III.18 Alternatives

NY 312 & PUGSLEY ROAD
TOWN OF SOUTHEAST, NEW YORK

COMMERCIAL CAMPUS AT FIELDS CORNER

ALTERNATIVE: BUILDING 4 POSITIONED CLOSER TO BUILDING 3

FIGURE: III.18 - 1

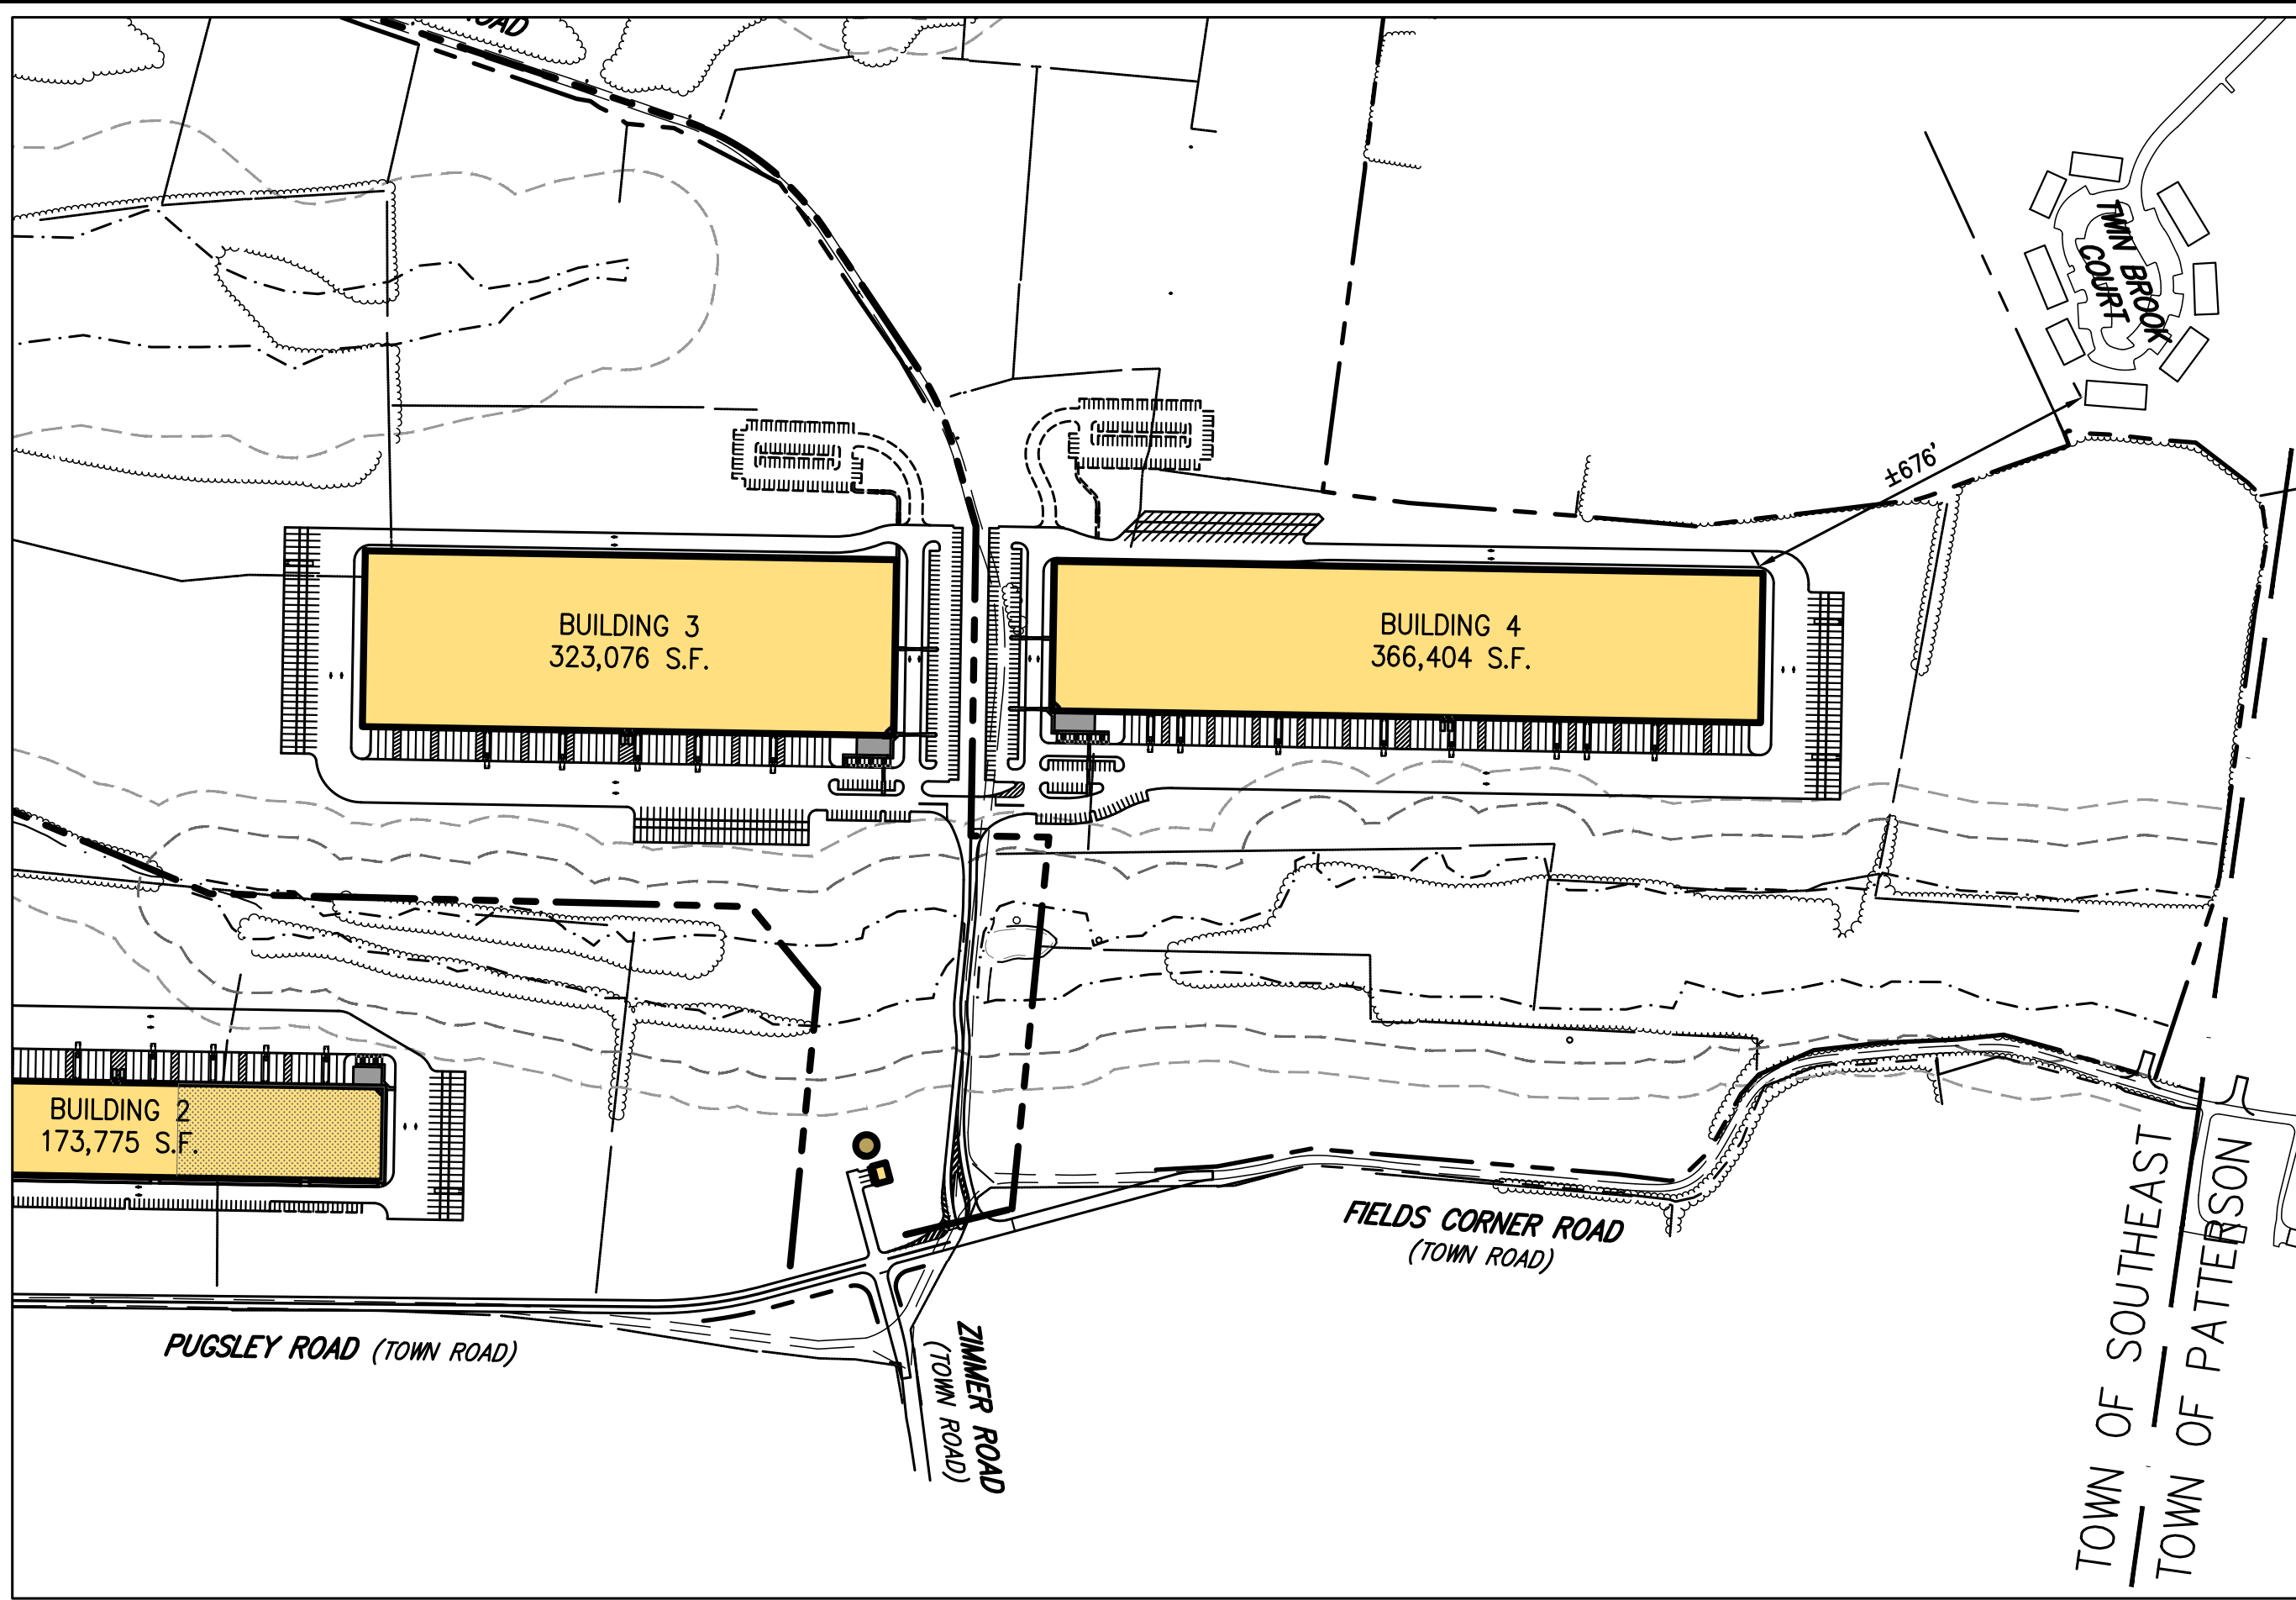
Comments No. 2-5 request various changes to the position/configuration of the proposed buildings on the site to provide greater separation from Twin Brook Manor.

a. Combining Buildings 1 & 2, and Buildings 3 & 4

The FEIS Alternative Plan, with two proposed buildings instead of four, accomplishes the objective of this alternative by providing a separation to Twin Brook Manor of approximately 1,210 feet versus the approximately 600 feet of the DEIS Plan.

b. Positioning Building 4 Closer to Building 3

As with the above response, the FEIS Alternative Plan accomplishes the objective of this alternative by combining Buildings 3 and 4 into Building B and thereby providing a separation to Twin Brook Manor of approximately 1,210 feet versus the approximately 600 feet of the DEIS Plan.
